# Access Compliance Report

## Public Rights-of-Way

### (Curb Ramps)

Intersection ID: 53925	Main Street: RORY_GLEN_LN	Cross Street: PINYON_PINE_LN	Location: SE
ADA ID: 039CF21BB450	Ramp Type: PerpDiag	Initial Pass/Fail: Fail	Overall Compliance: No
Severity Score: 36.25			
Codes/Mitigation Info/Possible Solution		Field Measurements/Component Compliance

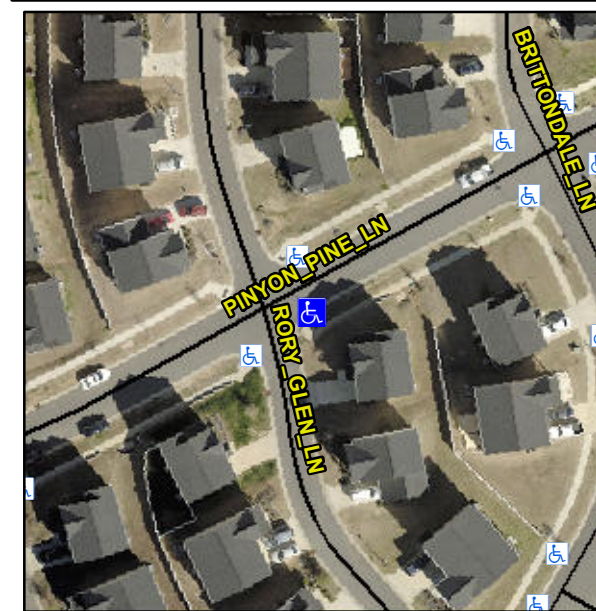
**R304.5.1, R304.5.3**

Compliance	Description	Data	Compliance	Description	Data
N/A	Ramp Length (in)	90.0	Yes	Ramp Slope (%)	6.9
No	Ramp Width (in)	24.0	No	Ramp XSlope (%)	2.3
N/A	Flare Type LT	N/A	N/A	Flare Type RT	N/A
N/A	Flare Slope LT (%)	N/A	N/A	Flare Slope RT (%)	N/A
N/A	Flare Traversable LT?	N/A	N/A	Flare Traversable RT?	N/A
N/A	Landing Length (in)	N/A	N/A	DWS Provided?	N/A
N/A	Landing Width (in)	N/A	N/A	DWS Contrast?	N/A
N/A	Landing Slope (%)	N/A	N/A	DWS Length (in)	N/A
N/A	Landing X Slope (%)	N/A	N/A	DWS Full Width?	N/A
N/A	Landing Curb? (Y/N)	N/A	N/A	DWS Offset (in)	N/A
N/A	Shared Landing?	N/A			
N/A	Gutter Ponding?	N/A	N/A	Gutter Slope (%)	N/A
N/A	Gutter Lip Ht (in)	1.0	N/A	Gutter X Slope (%)	N/A
N/A	Painted X Walk1?	No	N/A	Painted X Walk2?	No
	X Walk 1 Direction	To N		X Walk 2 Direction	To W
N/A	X Walk 1 Width (in)	N/A	N/A	X Walk 2 Width (in)	N/A
	X Walk 1 Slope (%)	5.5		X Walk 2 Slope (%)	7.8
	X Walk 1 X Slope (%)	2.8		X Walk 2 X Slope (%)	4.1

**Remove & Replace Curb Ramp With Two New Directional Ramps or Equivalent.**
